Belt 3 Loadout Modifications

VAA Project No. 260874

ADDENDA 004 - RFI LOG UPDATE - 08-25-26

SECTION 00 91 13

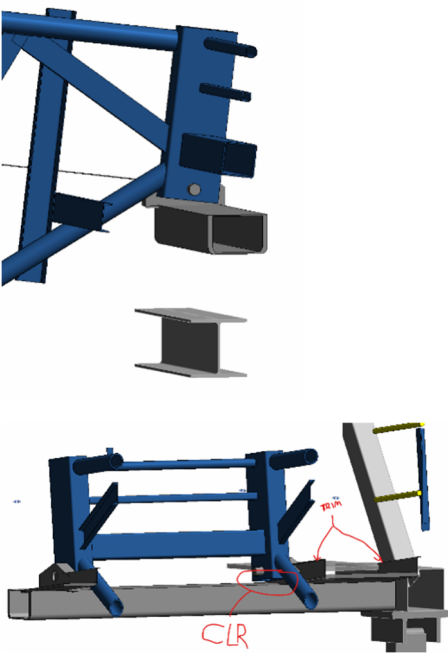
REQUEST	RESPONSE
A diesel supply line runs through the tower and conveyor structure; is modifying that in the contractor scope?	Yes
Did VAA perform an interference assessment on the pivot point of Conveyor #3 (it is believed the structural tubes will impact each other)	The pivot shouldn't affect any of the main tube members, but you may have to trim back some of the grating and the grating support members slightly on the pivot end from what VAA could see in the model based off the 3d scan. VAA scanned in that area and modeled it as accurately as possible and it appears there won't be any main member interference. <i>See snips below from the model.</i>
